Access Compliance Report Public Rights-of-Way (Curb Ramps)

Main Street: KITTRICK_DR Cross Street: HARRISBURG_RD Location: N

ADA ID: RPAT211202091447 Ramp Type: Type 1 - Perpendicular Diagonal Initial Pass/Fail: Fail Overall Compliance: No Severity Score: 2

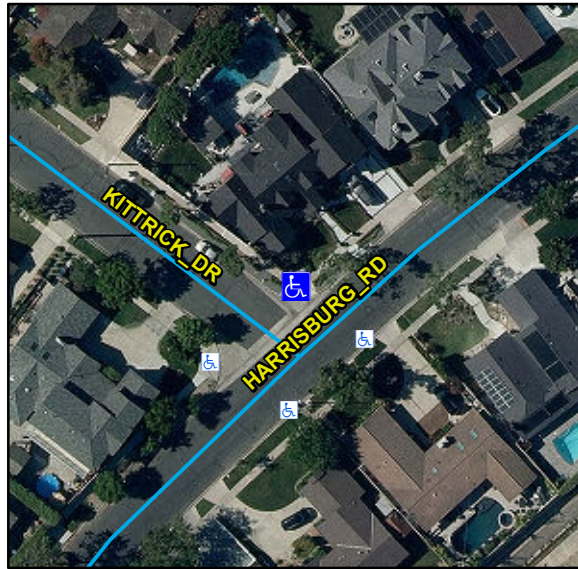
R304.2.2, R204.3, R304.5.3, STD 1115

Remove & Replace Curb Ramp With Two New Directional Ramps or Equivalent.
